The Highland Council

Agenda Item	10
Report No	SRC 06/13

Proposed Traffic Calming Feature on Millbank Road, Munloch

Report by Director of Transport, Environmental and Community Services

Appendix 1A

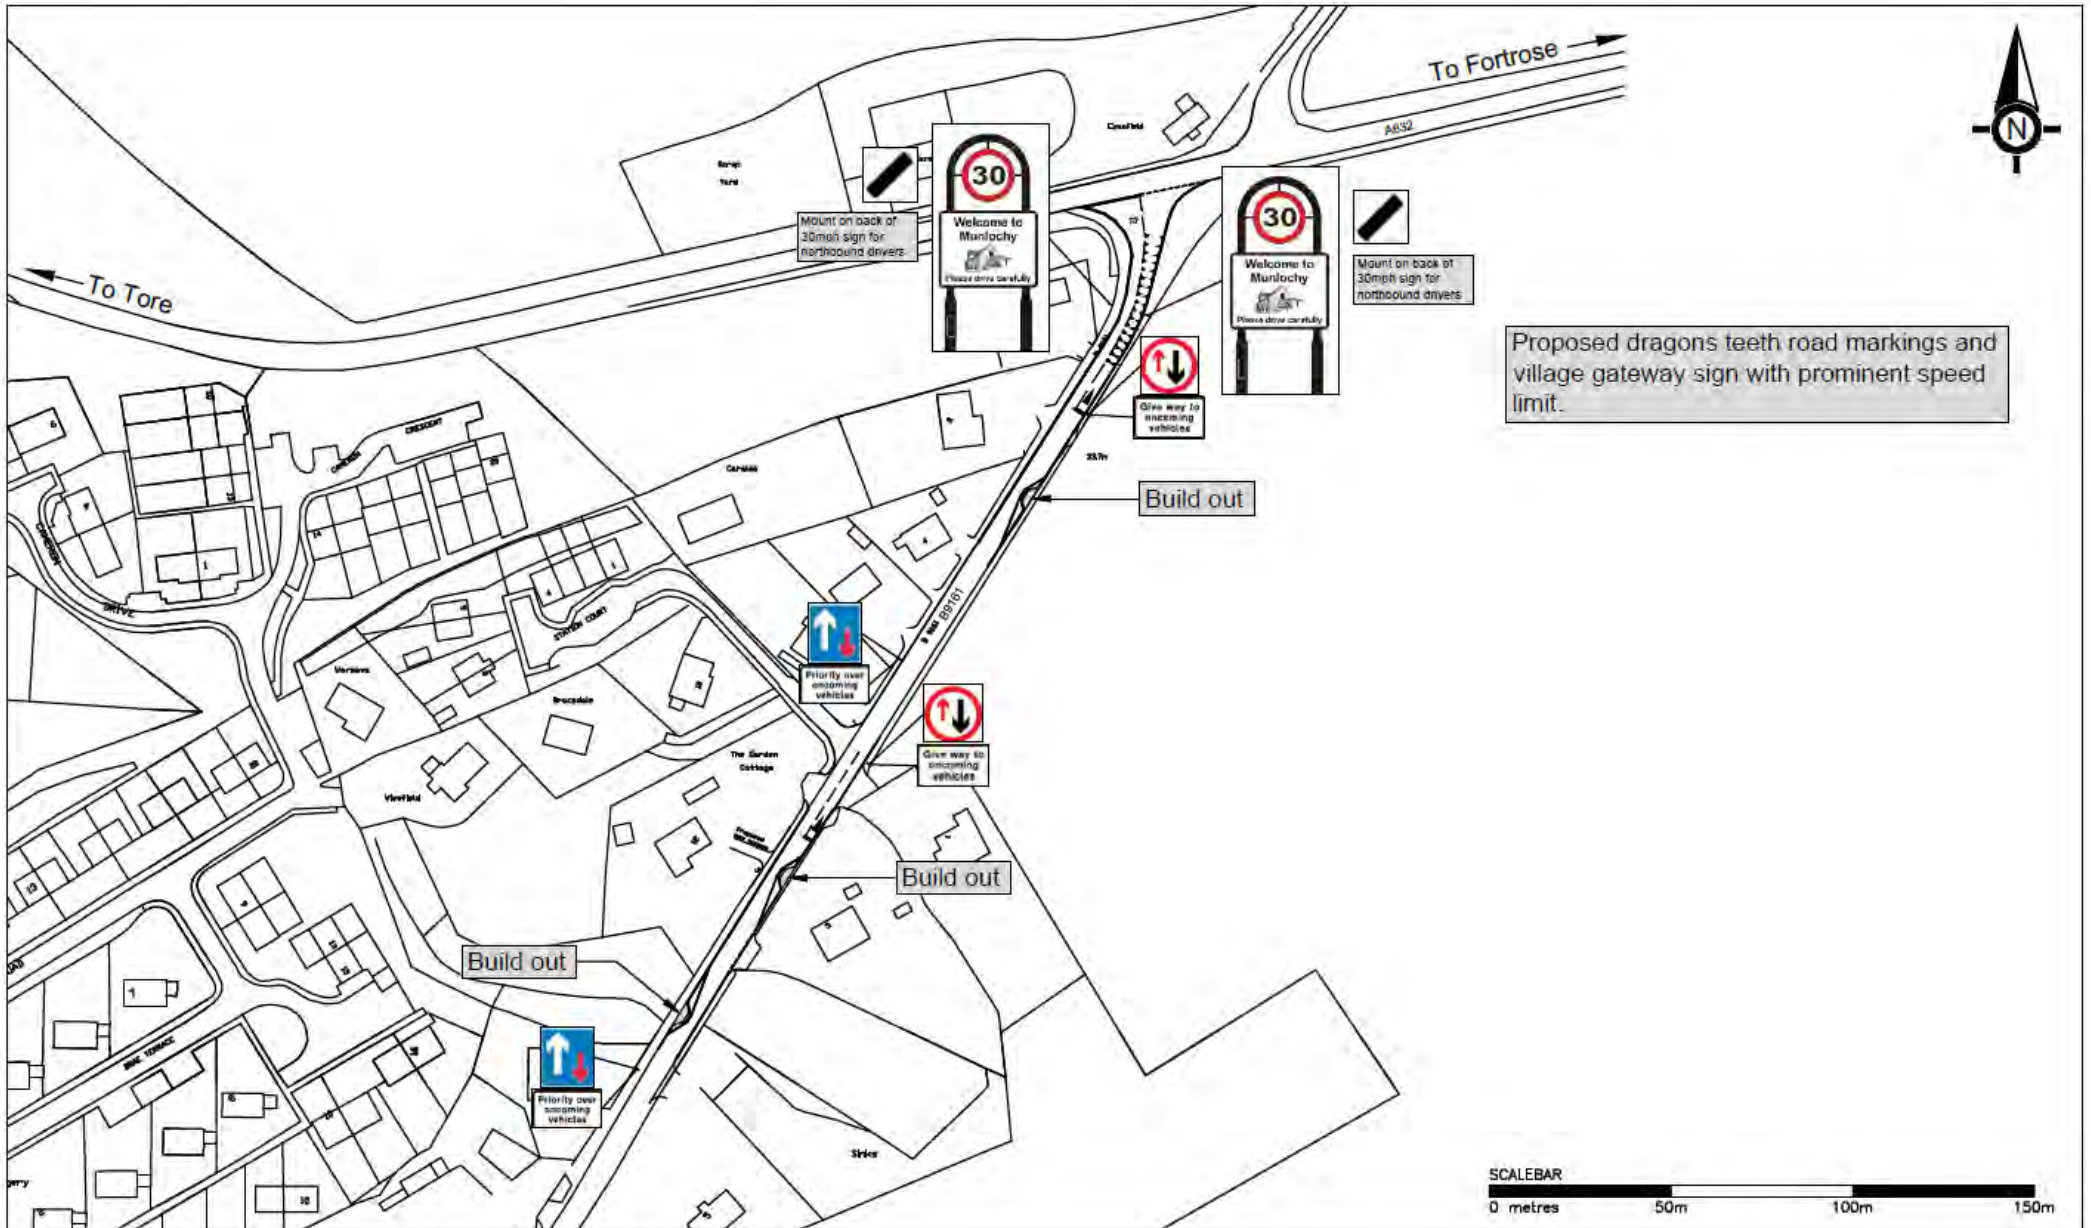
These plans were to be sent in draft form for display on the Council Notice Board at least 12 months ago, or more. They were never received. The Community have been denied the opportunity to comment on the details.

Apart from the Plan RC/MTM/13/001 we have no other proposals and these are the same as the residents have. Could you please advise what "all" implies, urgently. This item will be on our agenda at the Community Council meeting on Tues 18th June. I will recommend that a formal statement from the Knockbain Community Council be sent to you, following that meeting. Should you wish to send a representative to that meeting, it will be held in the North Kessock Village Hall at 7.30 pm.

- 1.2 The Highland Council, in consultation with the Community Council, have designed a package of traffic calming measures which are designed to reduce traffic speeds through Munloch. Plans showing all the features of the proposed scheme are contained in **Appendix 1A**.

PLAN NO. RC/MTM/13/001A

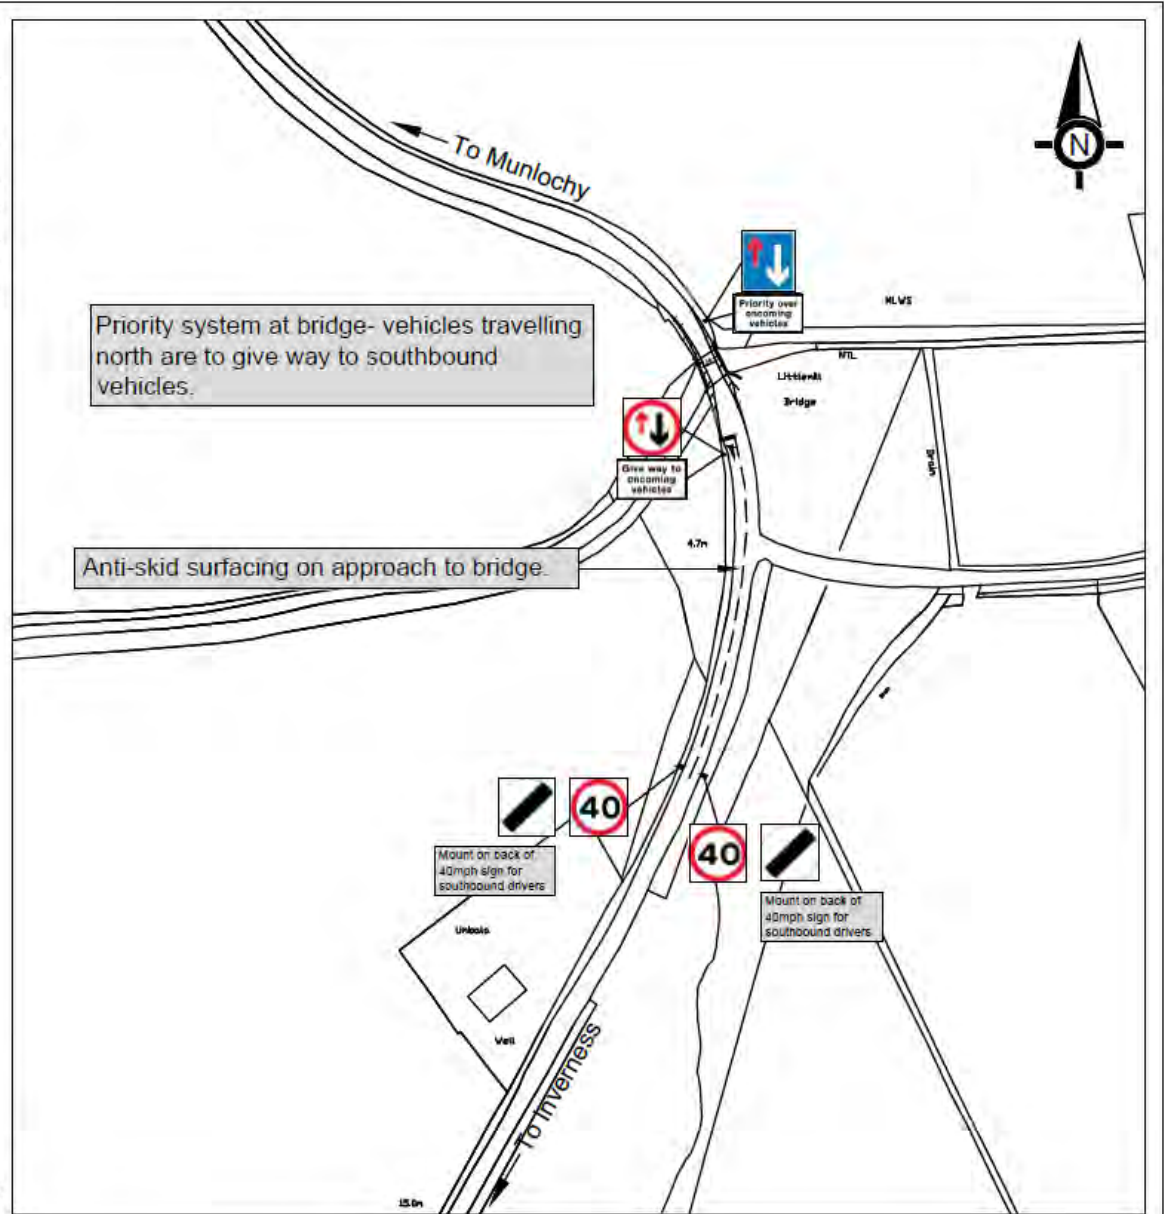
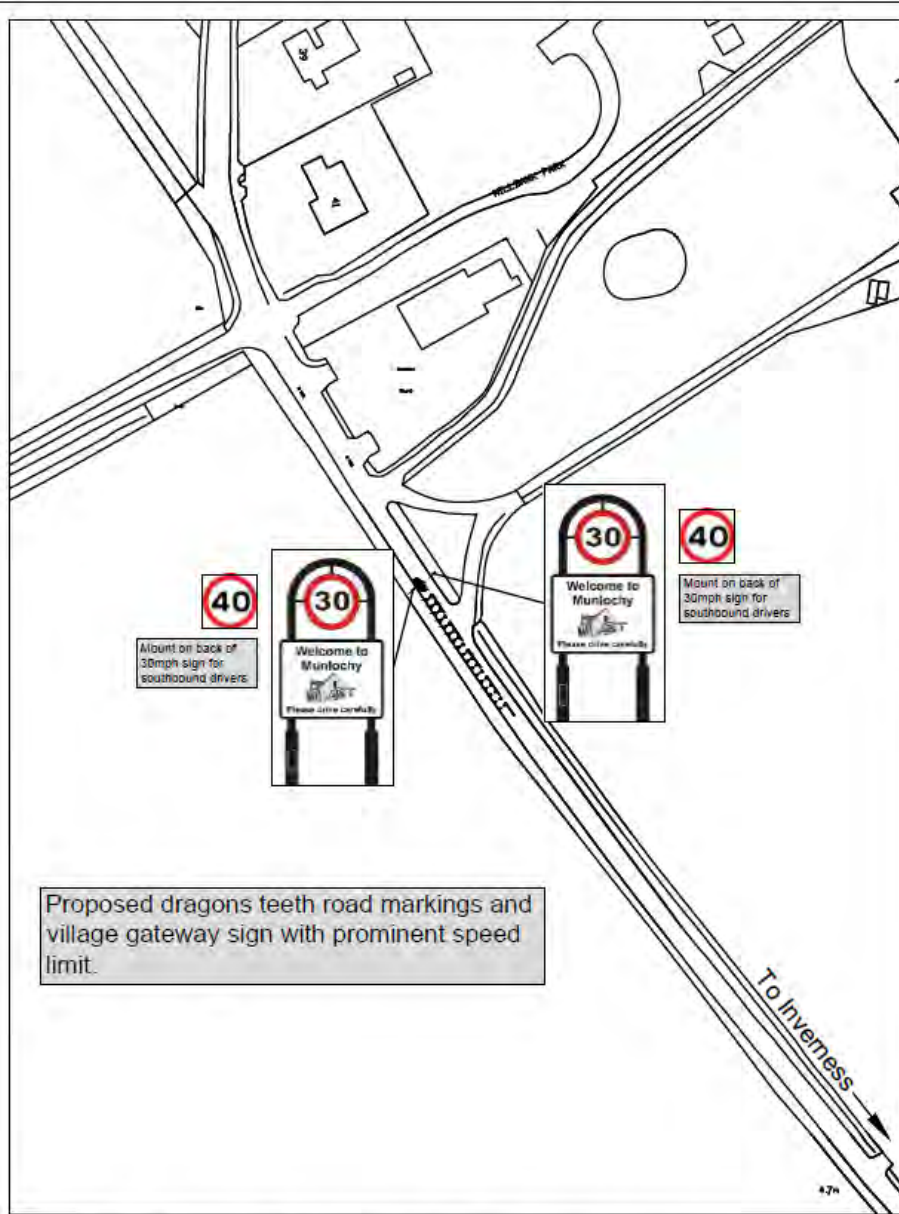
- Chicanes are an unsuitable traffic calming feature for a main road and will be a cause of frustration.
- The chicanes are considered to be obstructions put in place to encourage traffic to divert traffic via Tore, which would increase journey distance and time, wasting resources and causing more fumes to be emitted.

- Vehicles travelling uphill will be forced to stop and this will cause problems in wintery conditions.
- The build outs will cause congestion and restrict access to properties.
- The build outs will cause a build-up of traffic and this will seriously affect the junction of the B9161 / A832.
- The build outs will cause traffic to be diverted to the wrong side of the road and this will be hazardous to vehicles entering and exiting properties on this road.

- The proposed build outs will add to the present danger at the crossroads.
- The proposed build outs will cause traffic to stop and start and this would be a disturbance to the households located adjacent to the build outs.
- Vehicles may find it difficult to negotiate the build outs in wintery conditions.

- The objector has farms on both sides of Munlochy and needs to be able to move agricultural machinery through the village. The proposed build outs would cause difficulties in moving large agricultural vehicles which can be approx. 4m wide.
- The majority of pedestrians are in the area between the Hotel and the Hall and the build outs will not reduce traffic speeds in this area.
- The chicane will be ineffective.
- If the build outs encourage traffic not to travel through Munlochy this may have an impact on the viability of the Post Office and Shop. These not only provide services in the Village but also employment.

- The use of full height kerbs projecting into the carriageway is a hazard, particularly in wintery conditions. These kerbs, if struck by a vehicle,

After inspecting the plan, I feel that the siting of the chicanes will prove detrimental to the flow of traffic. It will result in vehicles becoming stacked back on the main Cromarty - Tore road therefore creating a safety issue for all concerned. At present, the lack of vision, plus the additional hazard of speeding vehicles makes it extremely difficult to emerge from either the Culbokie - Killen junction or Frasers garage.

- In the centre of the village the pedestrian crossing and car parking provide traffic calming and the traffic speeds in this area are lower.
- There have been no objections from the emergency services.
- The build outs have been designed to allow sufficient space for the agricultural machinery to pass through safely.
- The layout of the build outs has been carefully considered to avoid restricting access to any homes.
- The scheme is designed to slow traffic entering the village and improve the safety of pedestrians, cyclists and road users.
- It is proposed that LED illuminated flexible bollards will be positioned at each end of the build out. This should provide sufficient warning in wintry weather of the presence of the build outs on the carriageway.
- The scheme will be monitored to ensure there are no safety issues.

It is proposed that an LED illuminated flexible bollard will be positioned at each end of the build out to highlight it. This, along with the other associated road side signage, should provide sufficient warning in wintery conditions of the presence of the build outs on the carriageway.
